**BASEBALL STADIUM IN THE  
DIRIDON/ARENA AREA**

**FINAL ENVIRONMENTAL IMPACT REPORT  
VOLUME III**

APPENDIX I: First Amendment to Environmental Impact  
Report (Response to Comments)

BASEBALL STADIUM IN  
THE DIRIDON/ARENA AREA  
ENVIRONMENTAL IMPACT REPORT

FIGURE V.C-3  
(Revised)

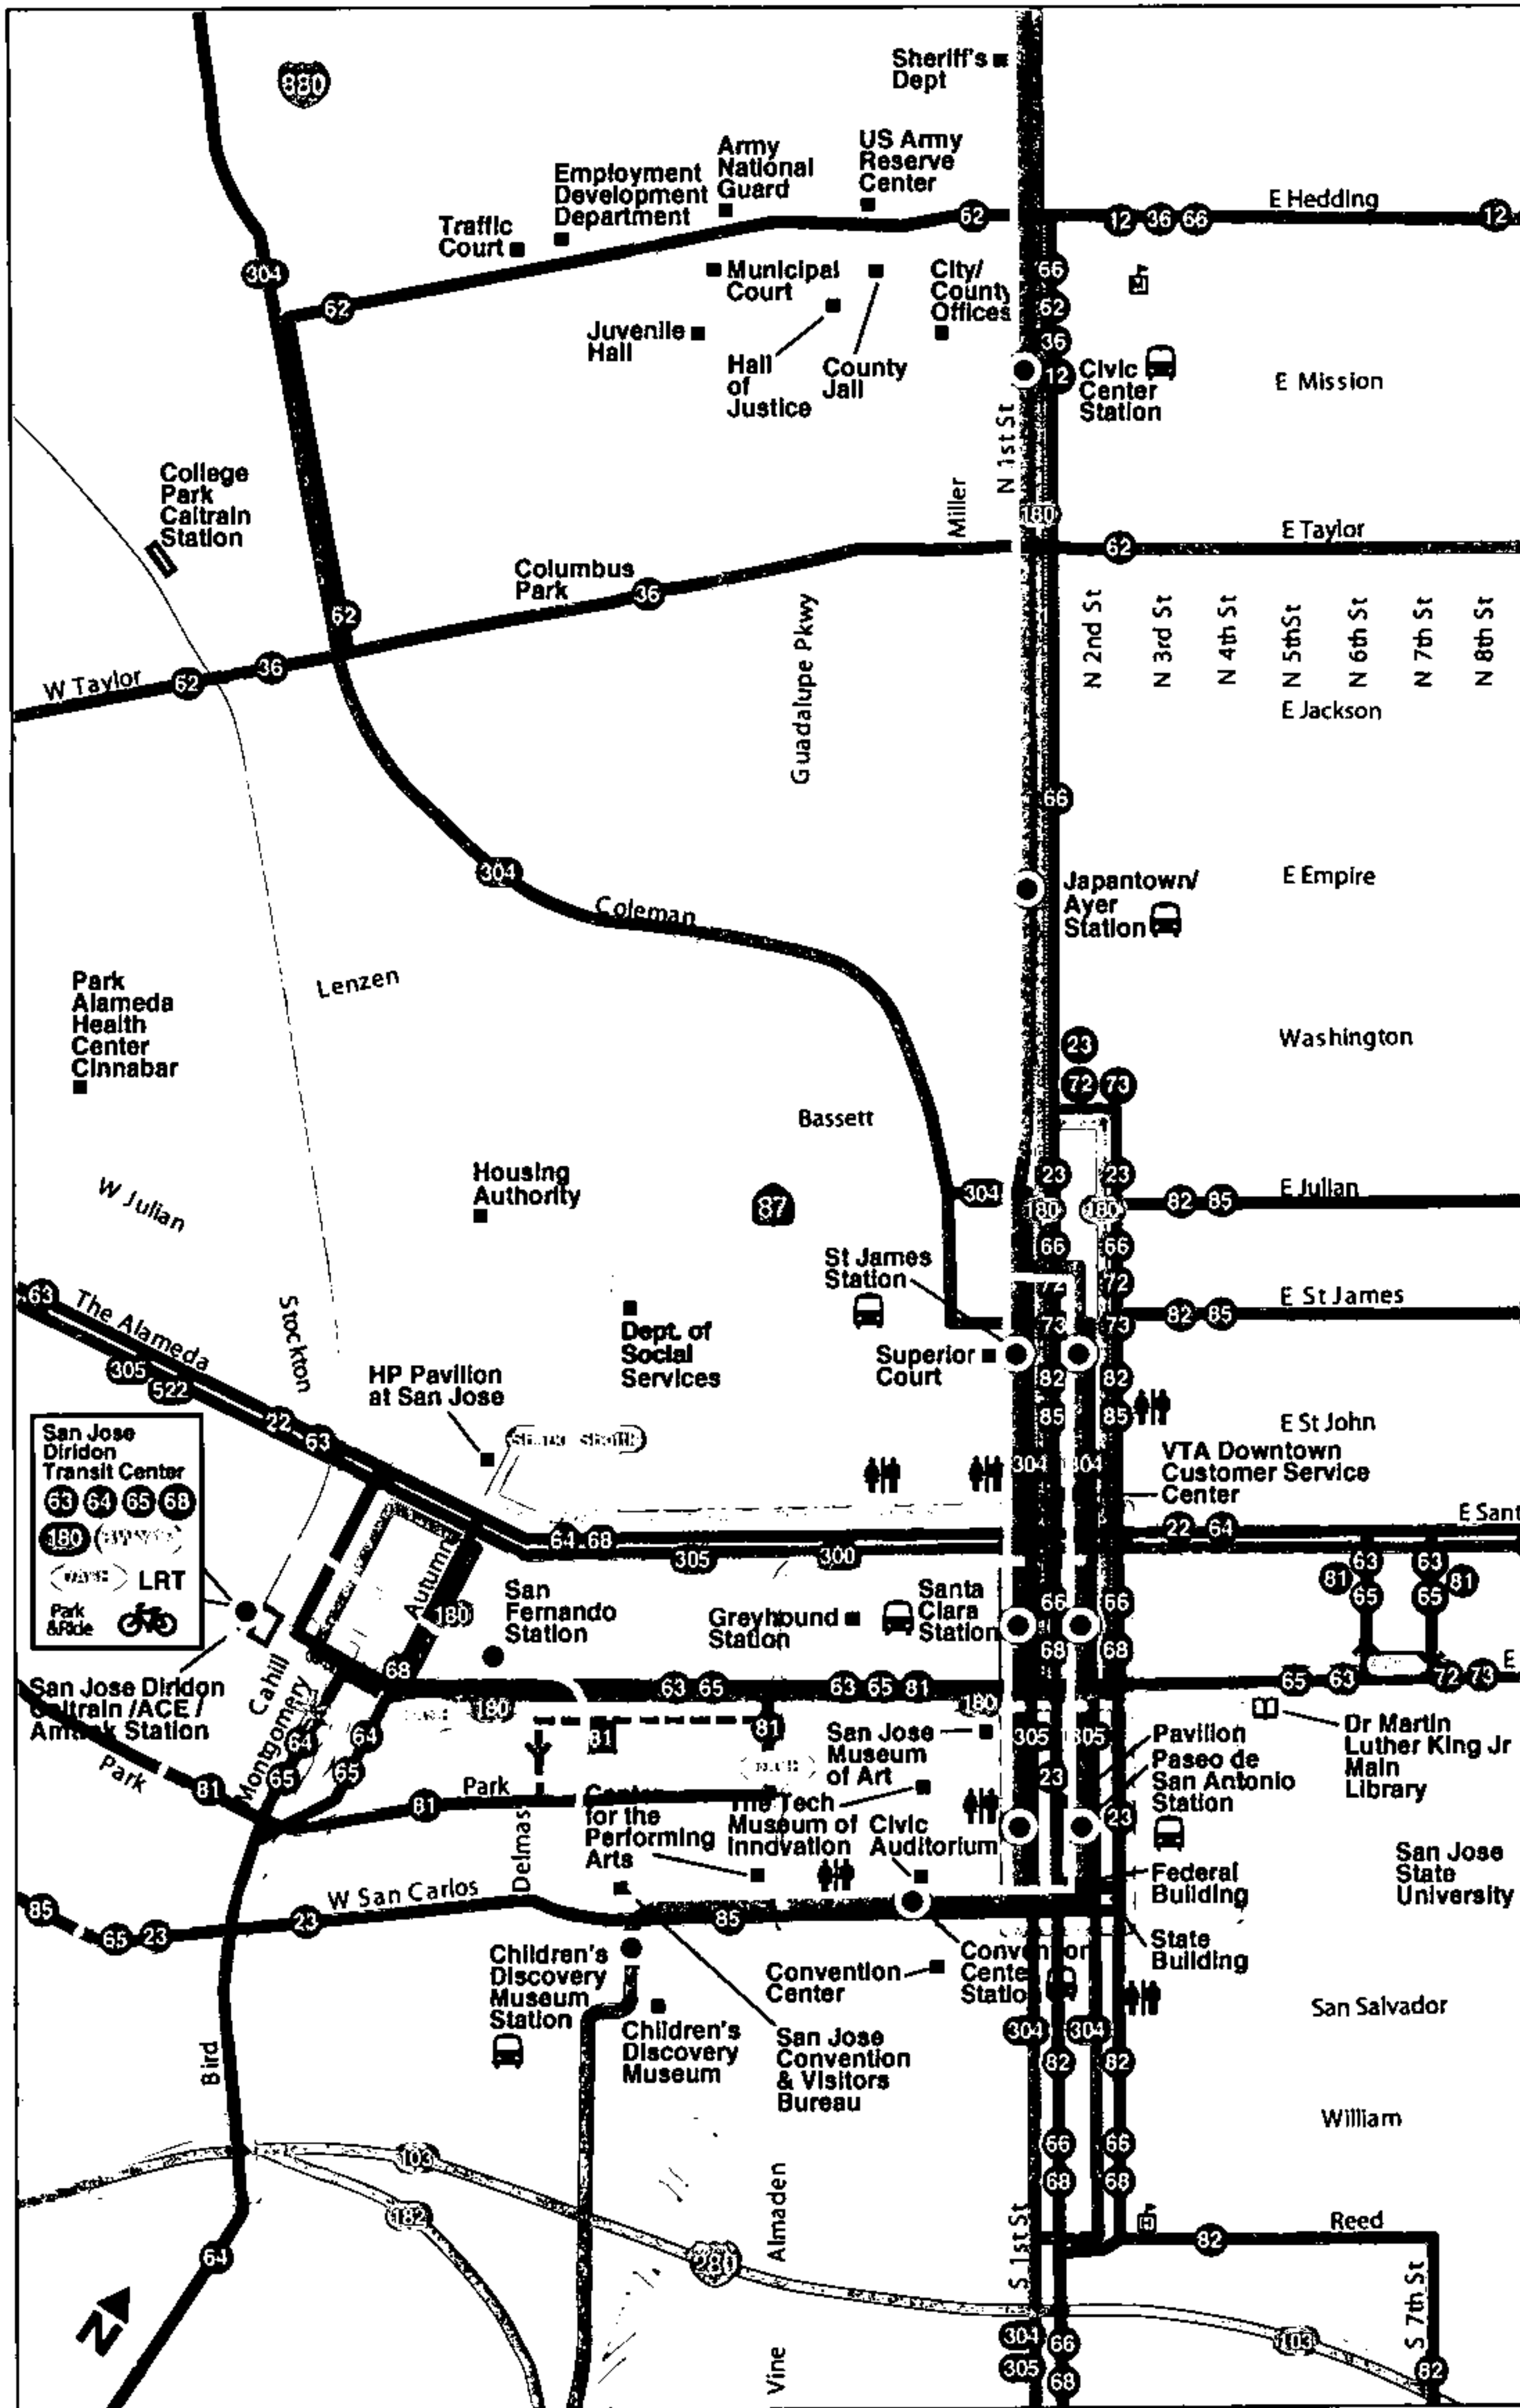
Figure V. C-3, Page 103, the map should clarify and identify the various modes of transit, (i.e. bus, light rail, heavy rail) in the map legend.

A2-36: A new version of Figure V.C-3 has been created to include a legend identifying the transit services.

FIGURE V.F-1  
(Revised)

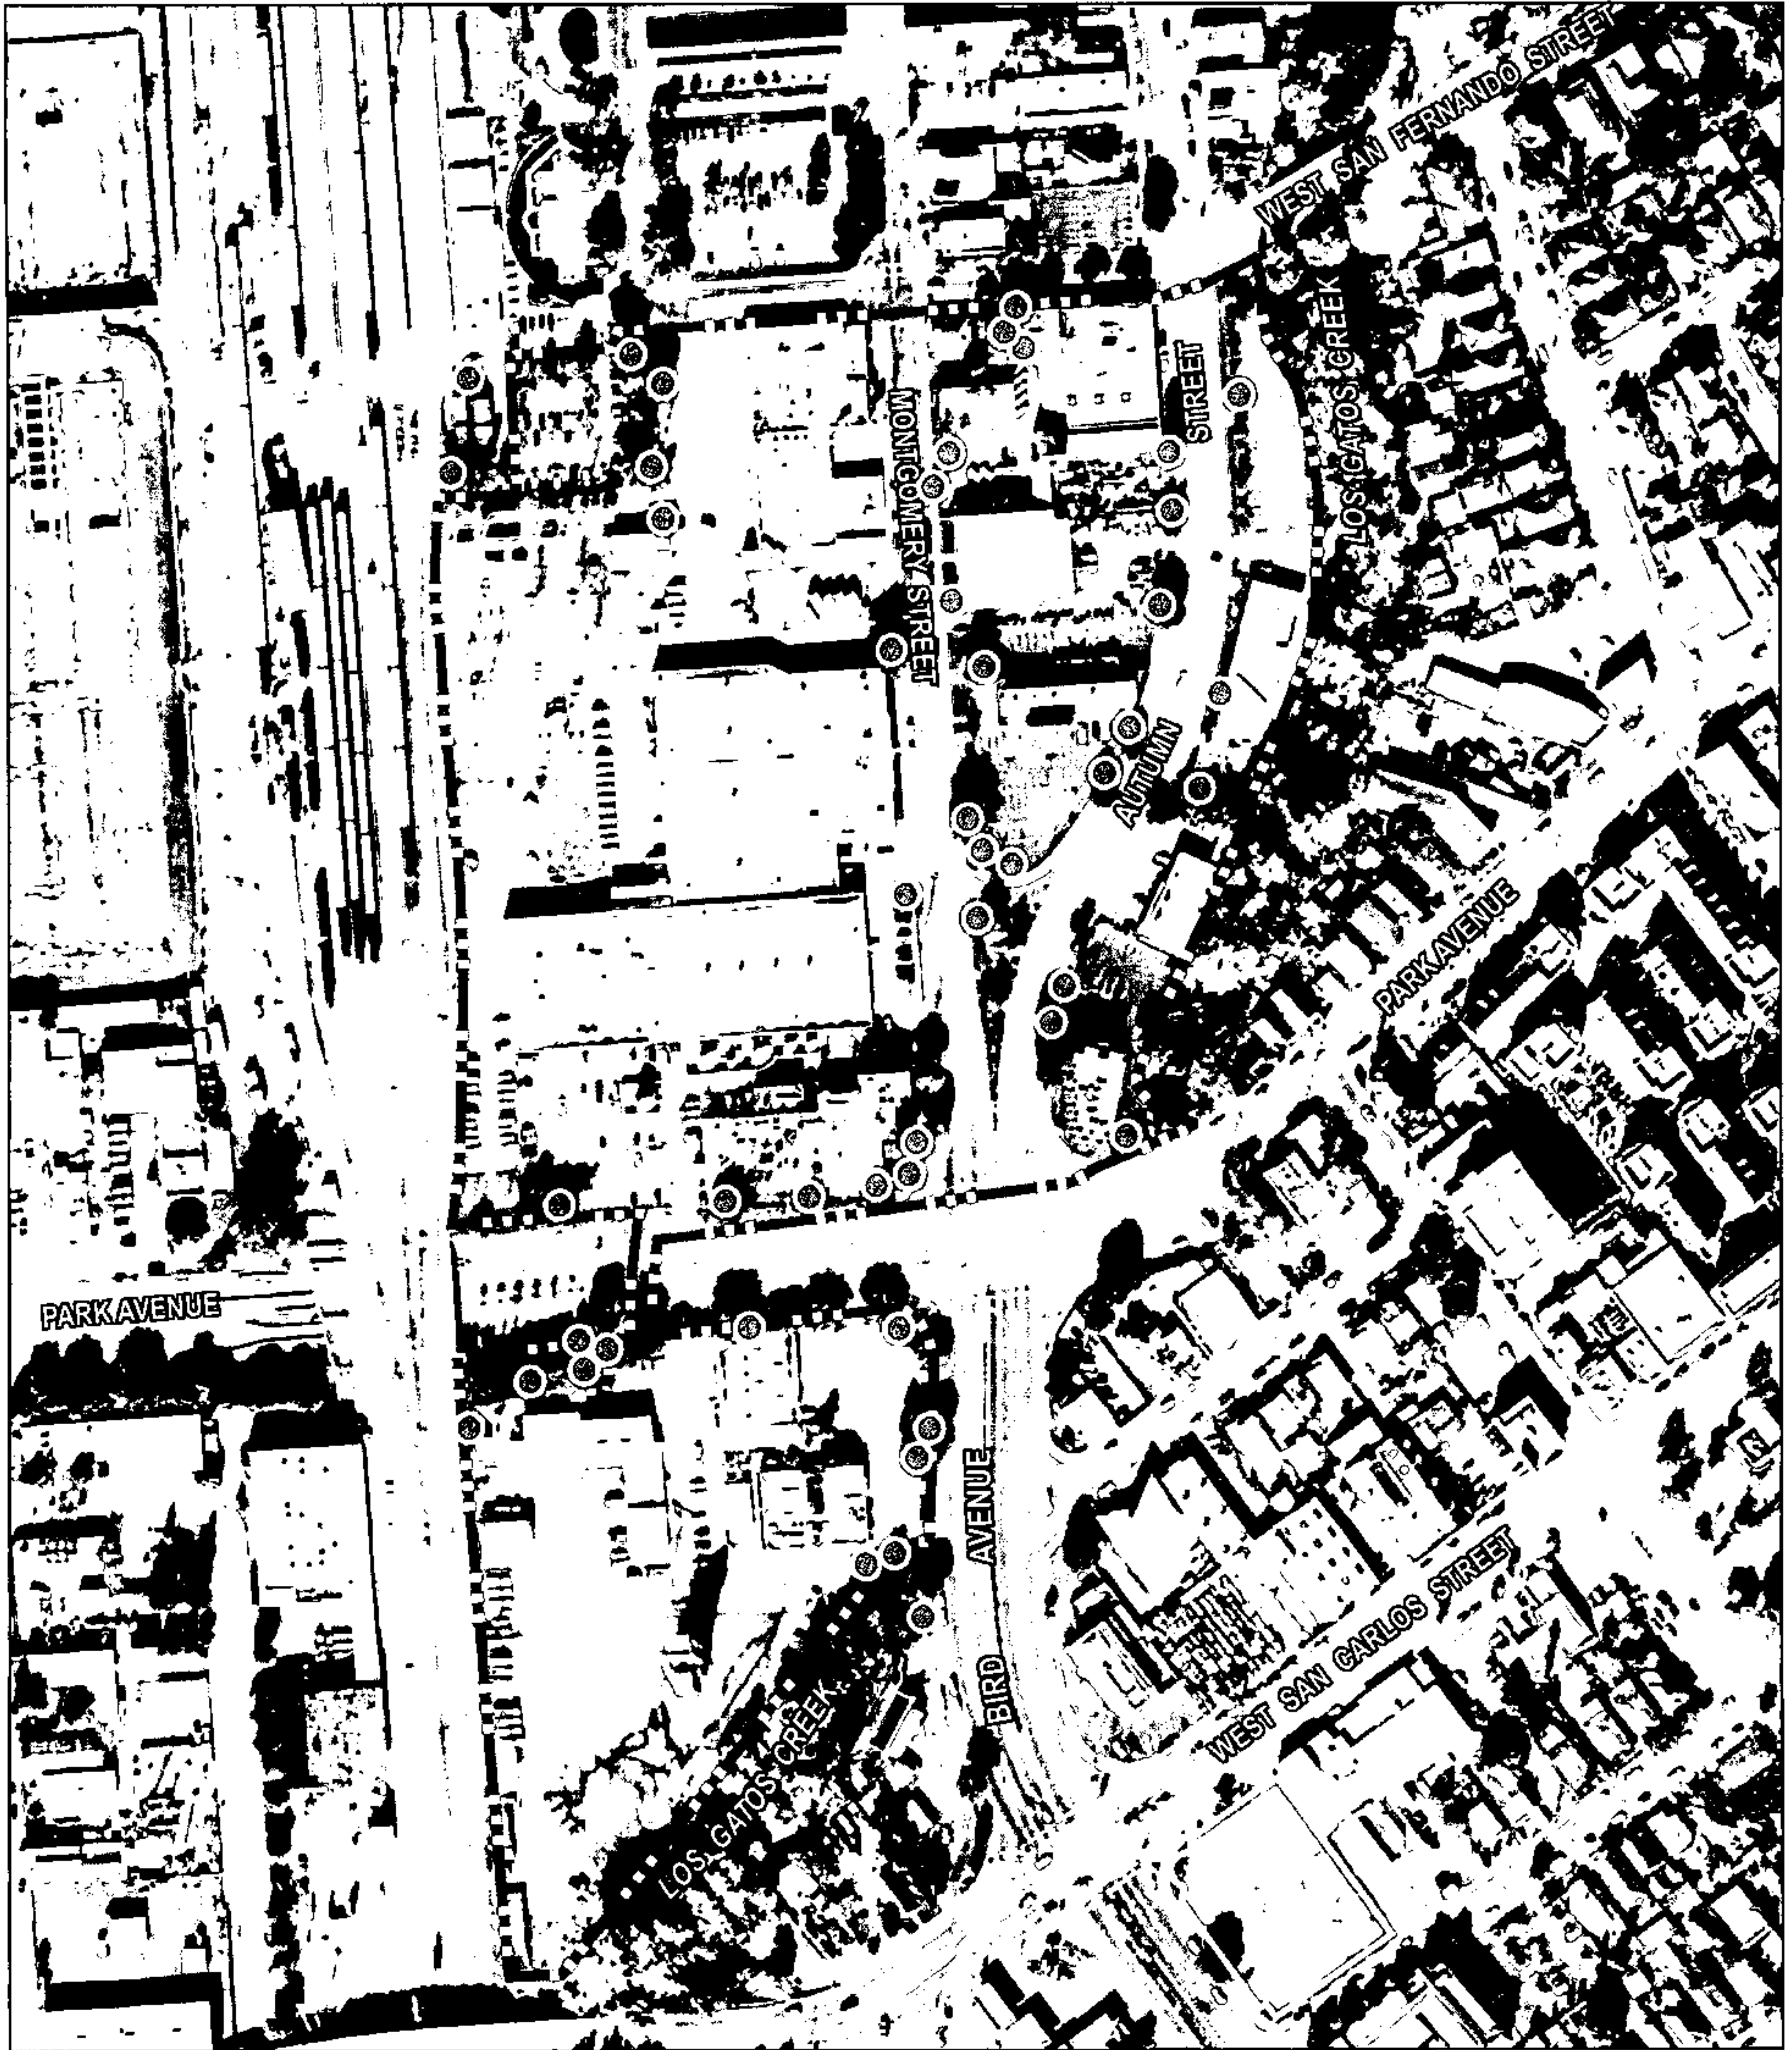
**Impact BIO-1: Construction of the proposed project would result in the removal of 45 ordinance-size trees. (S)**
